# Site Accessibility Evaluation

## Department of Human Services

**5850 Championship View  
Colorado Springs, CO  
80922**

**Accessibility Evaluation**

### Finding: 1

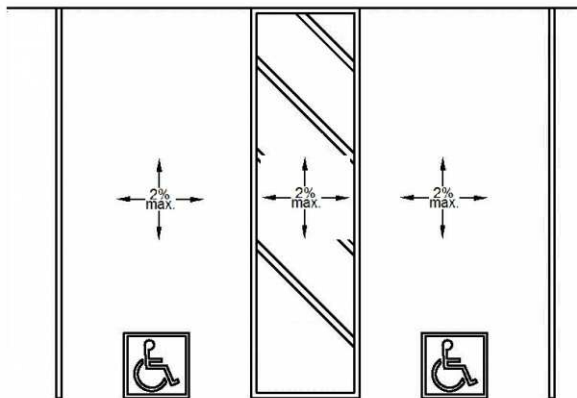
The accessible parking stall's access aisle contains a built up curb ramp which results in significant slopes greater than 2 percent.

Built up curb ramp protrudes into parking access aisle with a running slope of 12.3%

Remove protruding ramp and design/construct parallel curb ramp into existing sidewalk not to exceed 8.33% running slope, a landing on top a minimum of 48 inches with a cross and running slope not to exceed 2%.

### Finding: 2

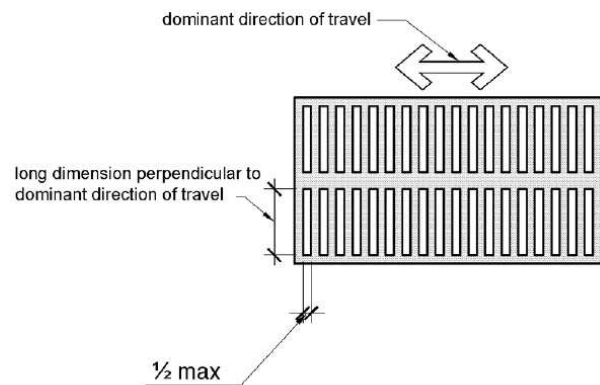
The concrete expansion joint is spaced greater than 1/2 inch.

Opening on top of protruding curb ramp  
2 inches wide

Remove protruding built up curb ramp and reconfigure sidewalk to incorporate a parallel curb ramp.

### Finding: 3

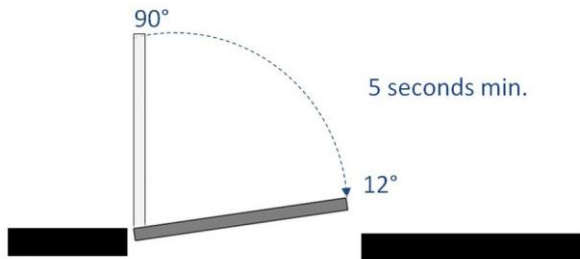
The door is equipped with a door closer and returns to a closed position too quickly.

2.8 seconds to a position of 12 degrees from the latch

Adjust door opener to a minimum of 5 seconds from an open position to a position of 12 degrees from the latch.

### Finding: 6

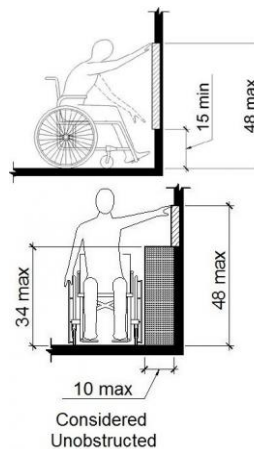
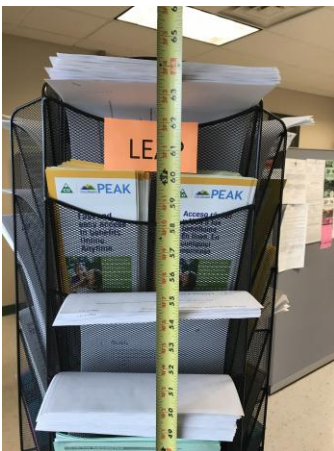
The informational stand is positioned too high for either a side or front approach.

Some informational brochures/applications placed beyond the 48 inch maximum

The applications, pamphlets and brochures located on the wall shelf and information stand respectively are located beyond the maximum reach allowable either for a forward or parallel approach. Height should be between 15 inches minimum and 48 inches maximum above finished floor for all printed material available to the public.

Provide different type shelves/informational stand to meet compliance.
